Plan Commission

Agenda

Monday, November 25, 2019

SUBJECT: Staff recommendation and possible action regarding a Site Plan request for a new office building and parking lot at 2100 BLK Innovation Court (Parcels WD-D0035-1-1, WD-D0036).

DRAWING NO.	
ES1.0	
PROJECT NO.	REV.
19065

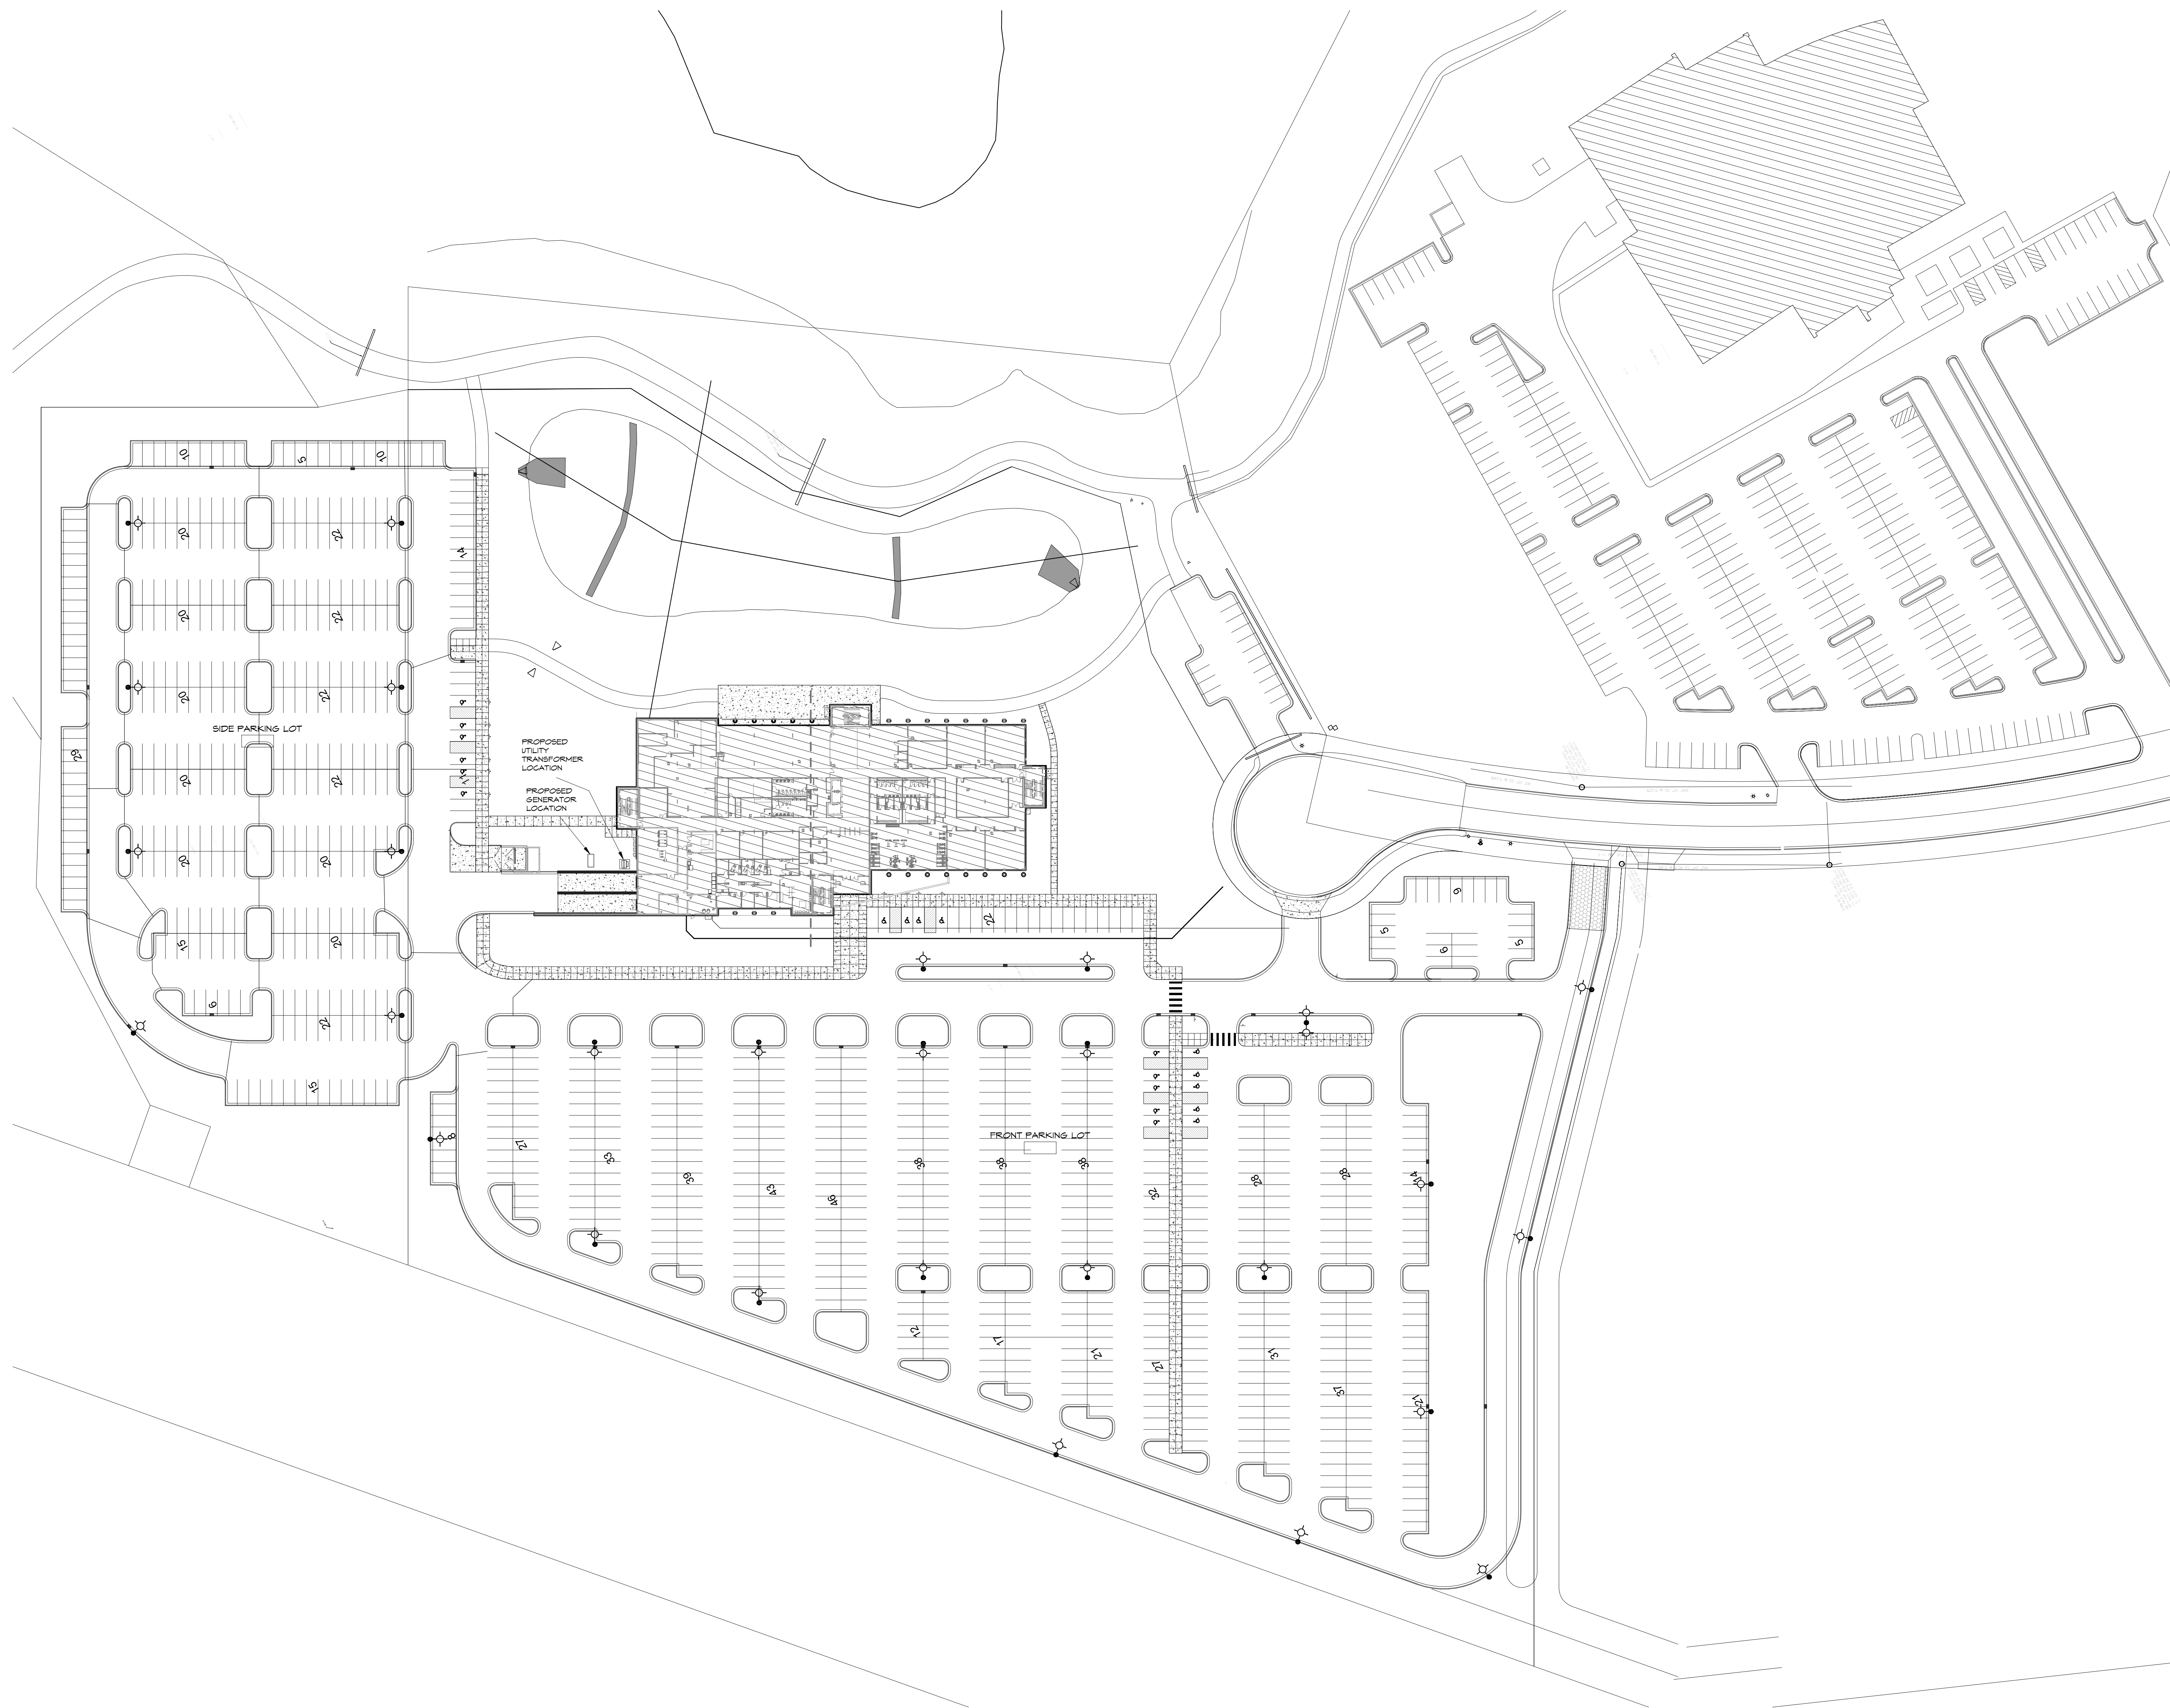
29. Sheet C7.1: The City requires inlet protection type D per WisDNR best management practices where applicable. No detail of this is provided.
 30. Sheet ES1.0: A lighting plan will need to be provided for the site showing the foot candles for all fixtures across this site.

31. Sheet ES1.0: Curb at north parking lot extends through parking stalls at the north and east side of the lot. Same for the southernmost lot to the east of the main lot (just north of the construction entrance).

C3-10

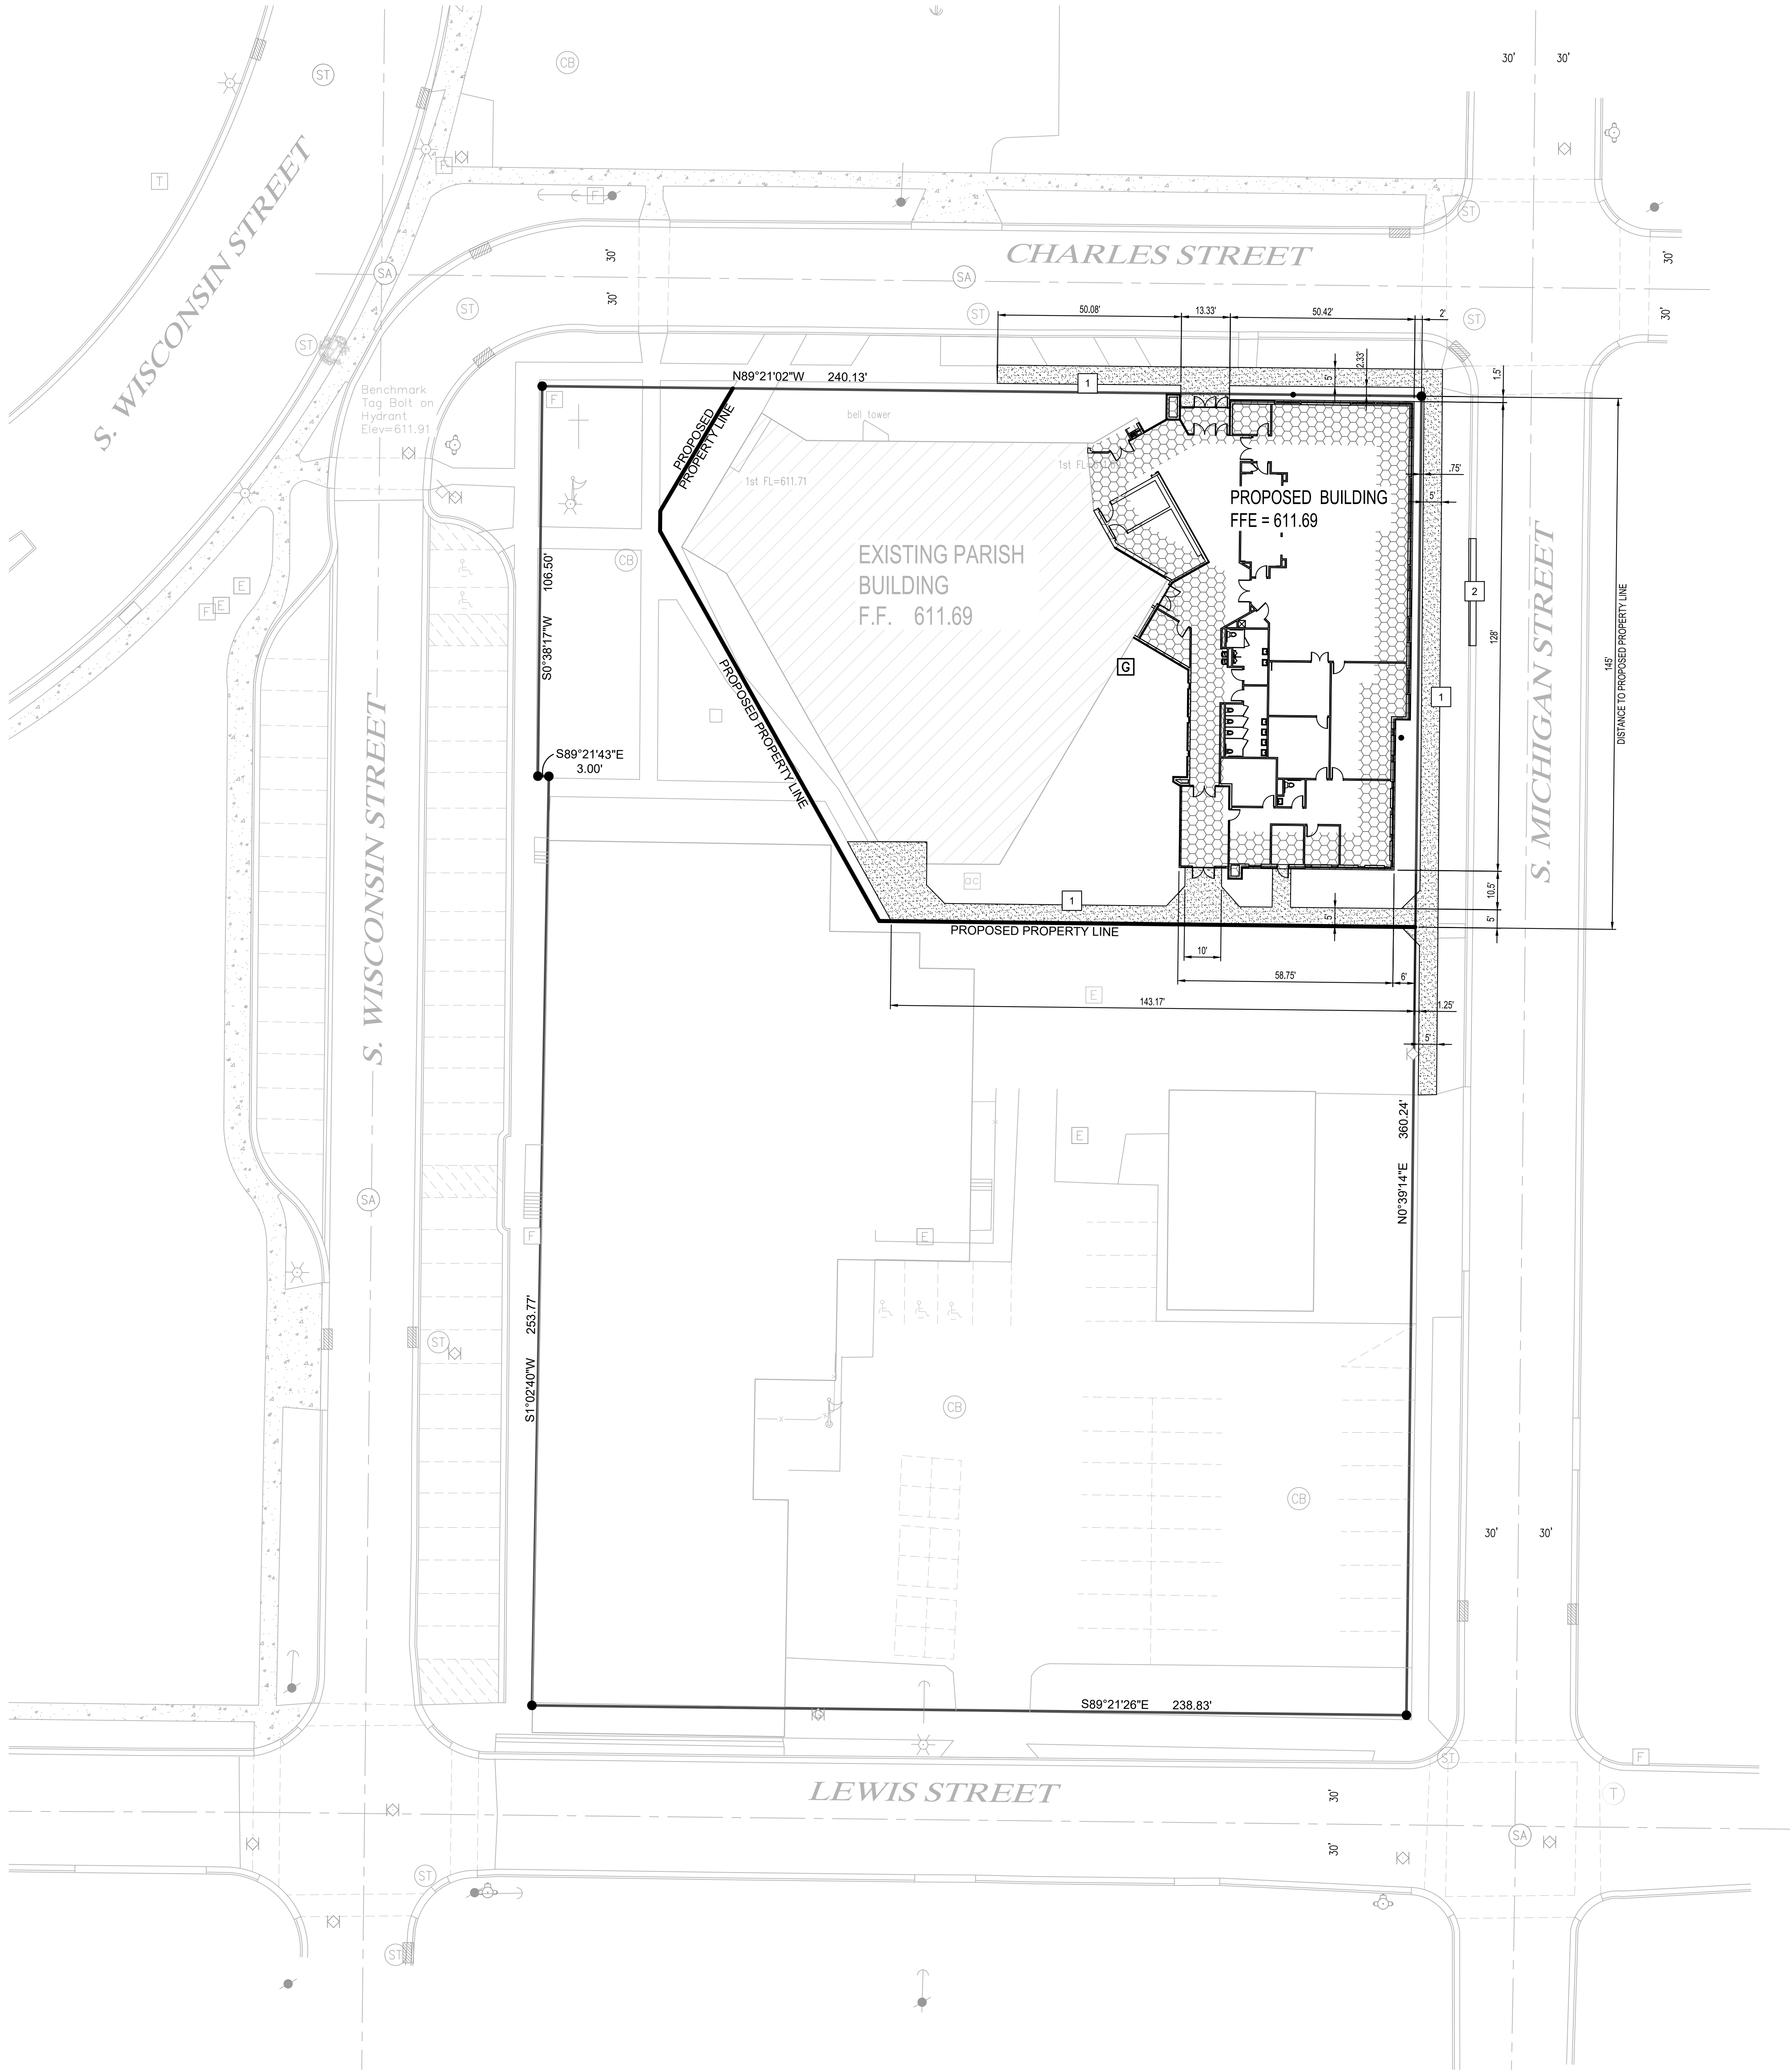
6. Sheet C2-10: In the demolition key, item 7 references a detail on sheet C0-20. This page is not included with the submitted set.
7. Sheet C3-10: Identify if there is a new gas line coming to the building.

8. Sheet C3-10: The excavation for the curb replacement will require a 2-foot asphalt patch along the curb pursuant to the City's Standard Specifications.

9. Sheet C3-10: In the construction key, both notes reference details on sheet C0-20 that are not included with this submittal.
10. Sheet C3-20: Missing sanitary sewer lateral invert elevations.
